SUBJECT: Minor Amendment to Tucson Medical Center Planned Area Development for Arcadia Wash Trail Figure 19E.

**Tucson Skilled Nursing Facility
Development Plan
30-16310-00**

Meeting Minutes

TUCSON MEDICAL CENTER SKILLED NURSING FACILITY
 AUGUST 8, 2016

THE SKILLED NURSING FACILITY SITE PLAN

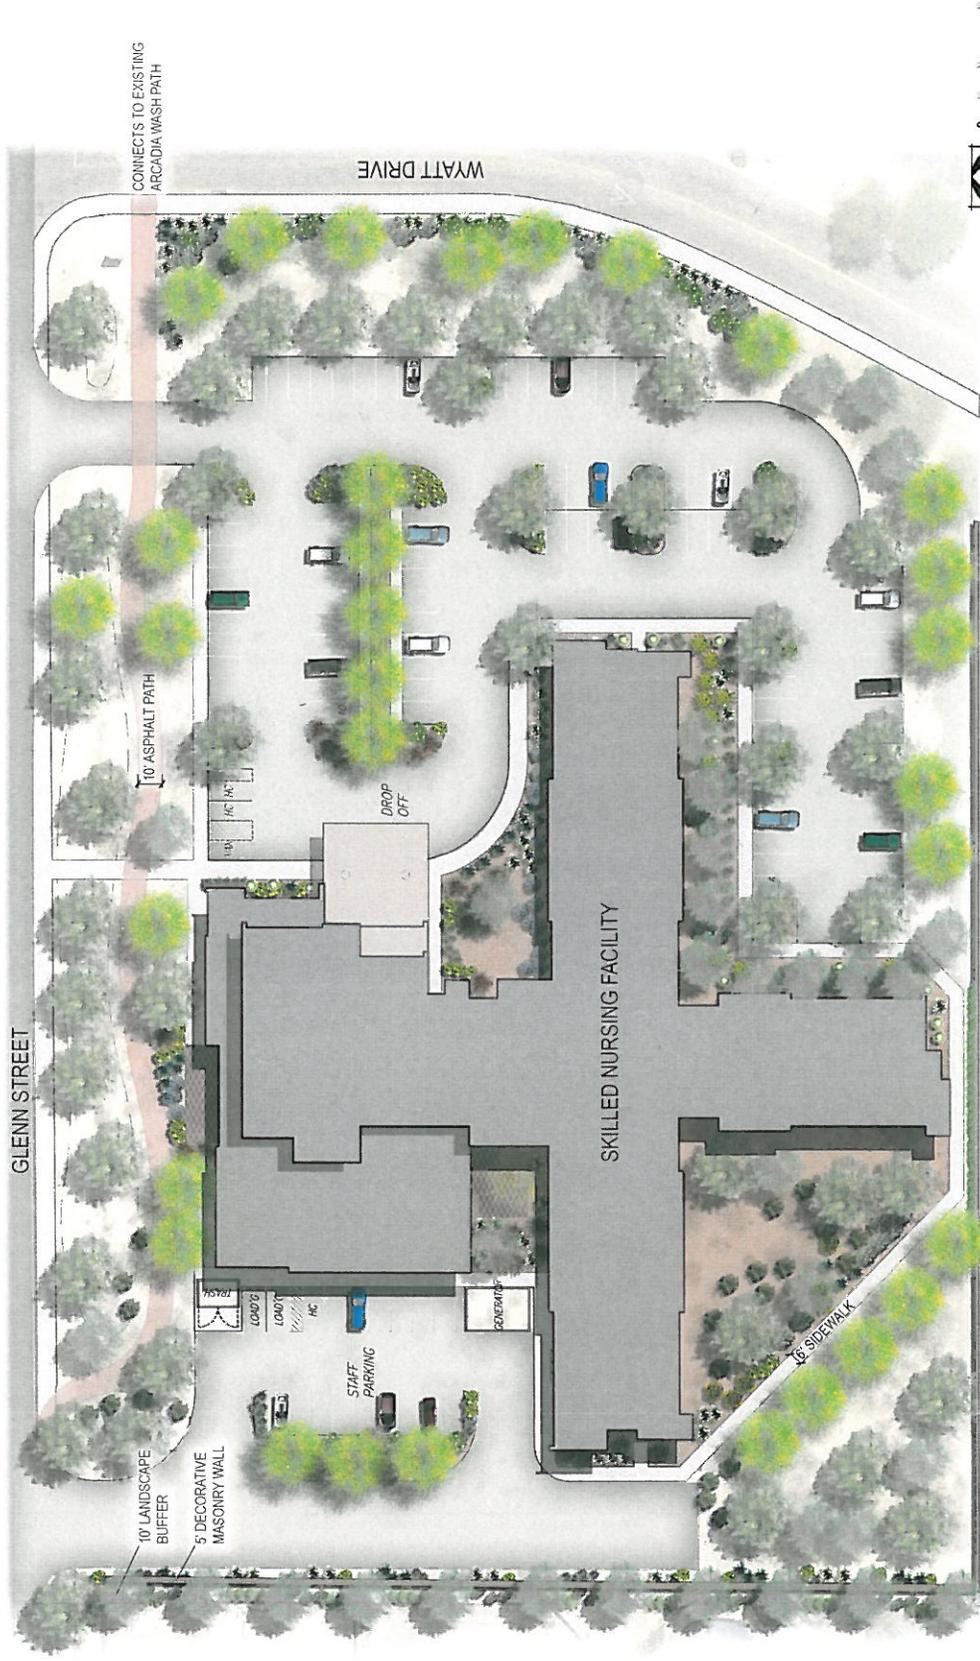
In reviewing existing conditions, it was confirmed that the distance from the top of concrete wash bank to the installed safety railing is 4'-0". A majority of the ground west of the railing is in excess of 10'-0" with a portion in the middle of the designated area being reduced to approximately 6'-0" in width where mature trees and parking lot light pole concrete bases are located. There are approximately six landscape areas in the parking lot adjoining the trail location with existing trees in three of the areas.

- The trail is required by the PAD.
- It is recognized that the full 30'-0" width of the pedestrian route and landscape border will impact existing parking adjacent to the trail.

- It is recognized that the full 10'-0' width of the trail can be accomplished except in the approximate 100'-0' length adjacent to the existing mature trees and parking lot light pole concrete bases.

- The trail will be allowed to be 8'-0" in width in the approximate 100'-0' length adjacent to the existing mature trees and parking lot light pole concrete bases with the safety railing being relocated 24" to the east still allowing for close to 3'-0" of safety zone along the top of the wash bank.

- Approximately ten parking spaces along the trail will be converted to landscape islands and planted with a minimum of 24" boxed trees and irrigated as required for healthy future growth.

- A 24" boxed tree will be planted in the interior landscape island of the parking lot at the southern end of the lot to balance out the existing vegetation.

- The north end of the trail will need a rip rap bank to level out the final 30'-0" +/- of trail prior to connecting with the existing trail and bridge.

- The existing railing will need to be modified to allow for the desired width of the trail at the north connection.

- The southern end of the trail will connect with the existing concrete sidewalk and accessible curb ramp. In order to achieve the correct slopes for accessibility, the grade at the southern end of the trail will be required to be elevated.

Hence, it is determined that your request to modify the Conceptual Pedestrian Circulation, Figure 19E as it relates to the Arcadia Wash Trail north of Wyatt Drive is a non-substantial change and may be approved as a Minor Amendment, subject to the direction agreed upon in your attached letter dated July 28, 2016, and the Trail Exhibit dated August 8, 2016.
